# Access Compliance Report Public Rights-of-Way (Pedestrian Signals)

Intersection ID: N/A	Main Street:	Cross Street: N/A	Location: N/A
ADA ID: 64C02EE39D11	Signal Type: One Push Button-Non APS	Overall Compliance: No	Severity Score: BTN 1: N/A BTN 2: N/A No BTN: N/A
Codes/Mitigation Info/Possible Solution		Field Measurements/Component Compliance

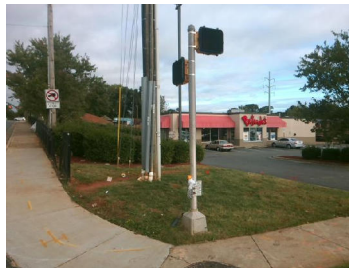
PROW/ADA: TMUTCD 4e.08, R406.2, R404.7.3

N/A	B 1 FWD Approach Width (in)	N/A	N/A	B 2 FWD Approach Width (in)	N/A
N/A	B 1 FWD Approach Obstruction?	No	N/A	B 2 FWD Approach Obstruction?	N/A
N/A	B 1 FWD Approach Obstruction Dist (in)	N/A	N/A	B 2 FWD Approach ObstructionDist (in)	N/A
N/A	B 1 PARA Approach?	Yes	N/A	B 2 PARA Approach?	N/A
N/A	B 1 PARA Approach Constrained?	No	N/A	B 2 PARA Approach Constrained?	N/A
No	B 1 PARA Approach Reach (in)	16.0	N/A	B 2 PARA Approach Reach (in)	N/A
N/A	B 1 PARA Approach Width (in)	N/A	N/A	B 2 PARA Approach Width (in)	N/A
N/A	B 1 PARA Approach Obstruction?	No	N/A	B 2 PARA Approach Obstruction?	N/A
N/A	B 1 PARA Approach Obstruction Dist (in)	N/A	N/A	B 2 PARA Approach ObstructionDist (in)	N/A
Yes	B 1 Clear Floor Space Slope (%)	5.0	N/A	B 2 Clear Floor Space Slope (%)	N/A
Yes	B 1 Clear Floor Space XSlope (%)	1.8	N/A	B 2 Clear Floor Space XSlope (%)	N/A
N/A	B 1 PAR Slope (%)	10.9	N/A	B 2 PAR Slope (%)	N/A
Yes	B 1 Height (in)	38.0	N/A	B 2 Height (in)	N/A

Yes	B 1 Clear Xing Direction?	ClearlyMarked	N/A	B 2 Clear Xing Direction?	N/A
	B 1 Crossing Direction	To E		B 2 Crossing Direction	N/A
Yes	B 1 DistanceTo XWalk (in)	0.0	N/A	B 2 DistanceTo XWalk (in)	N/A
No	B 1 DistanceTo Curb (in)	100.0	N/A	B 2 DistanceTo Curb (in)	N/A
Yes	B 1 Diameter (in)	2.0	N/A	B 2 Diameter (in)	N/A

Possible Solutions: Replace Signal Push Button With APS Button on New Post. Remove & Relocate Sign.
